Owner Occupied and Scattered Site Rehabilitation Programs

**Addendum # 2
December 9th, 2016**

Project # 1236 Property Address: 12 Oliver Street, Norwalk, CT

1. The purpose of this addendum is to respond to a request for information received during the bidding phase and to replace drawing sheet A-1.1 – Floor Plan Proposed Conditions. Bidders are reminded that all requests should be directed to Mr. Richard Couch, P.E. of Martinez Couch & Associates, LLC

Drawing Sheet A-1.1 – Floor Plan Proposed Conditions

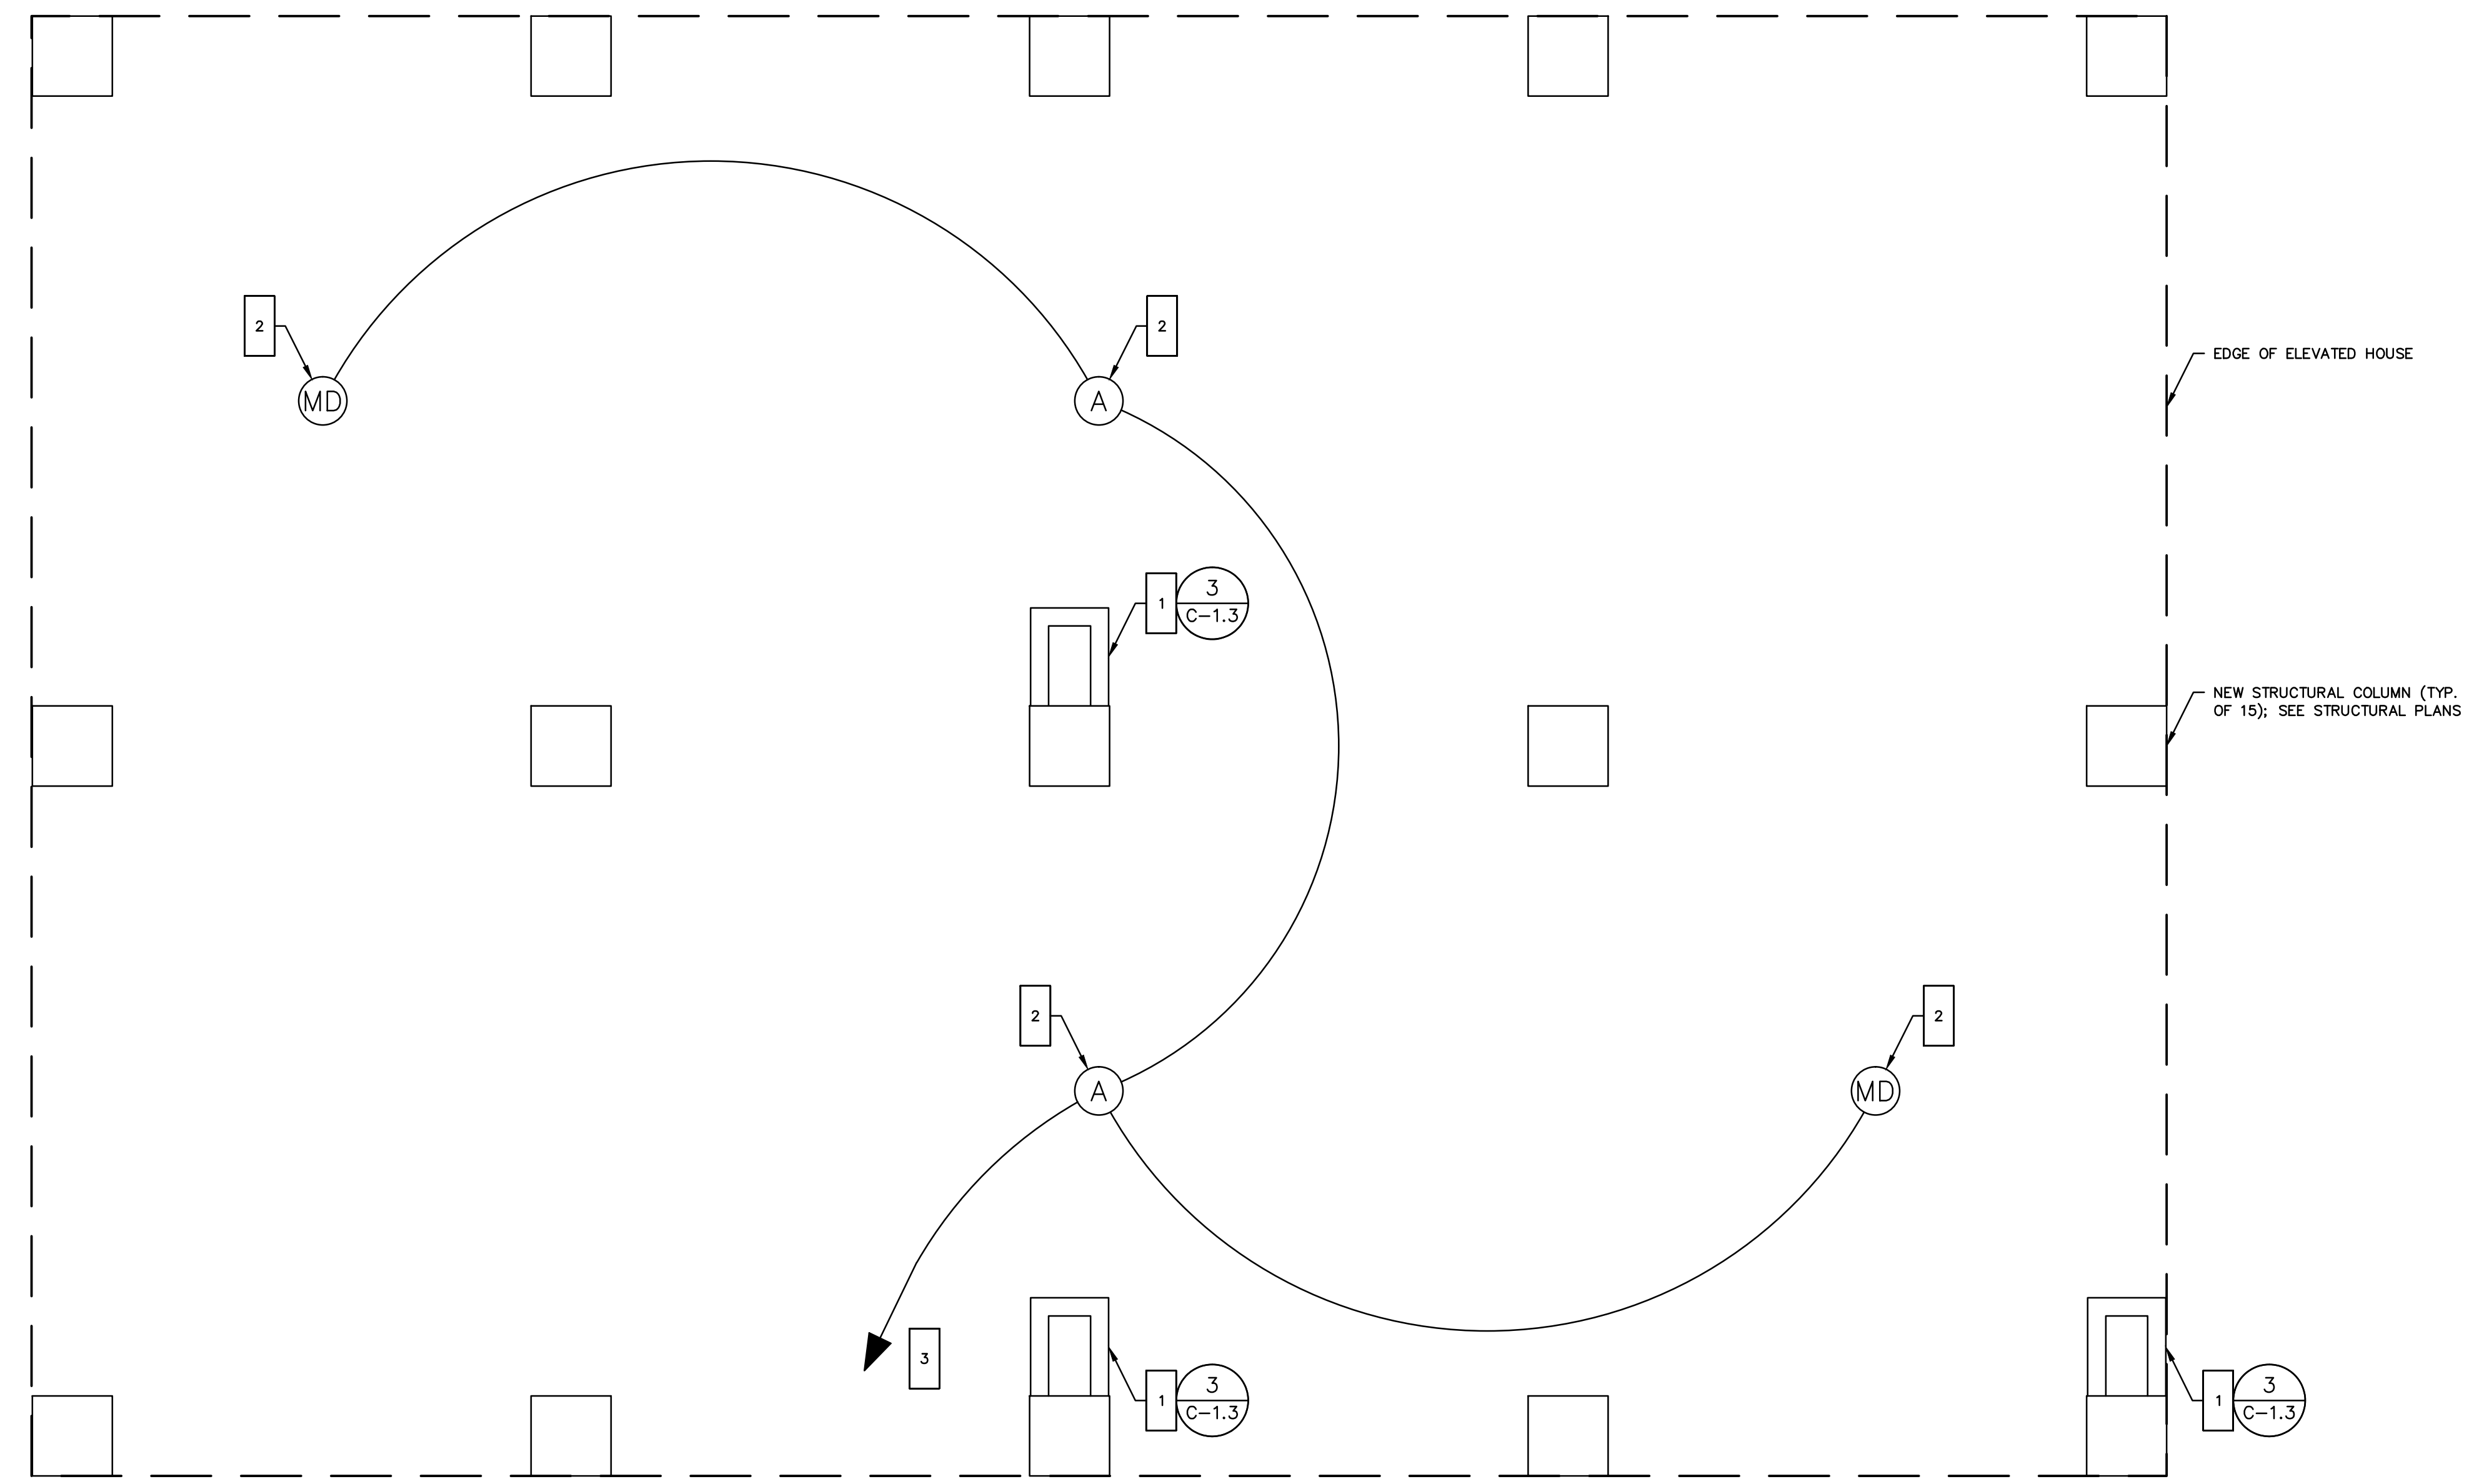
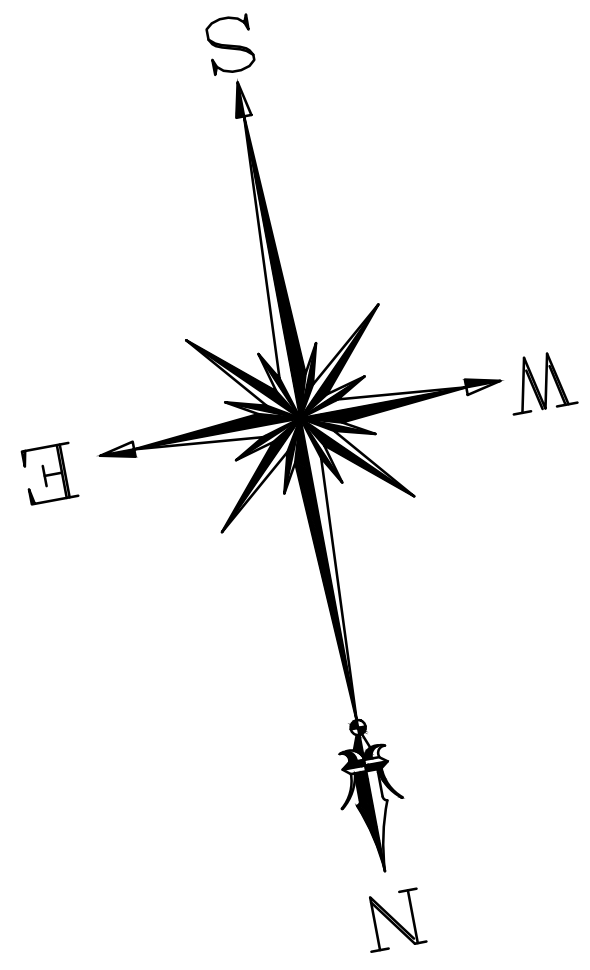
A-1.1, note 1: with the natural gas connect, there's no need for the fuel tank?

See drawings C-1.1 Note 7 and 9, the heating fuel tank, contents and associated piping are to be disposed offsite.
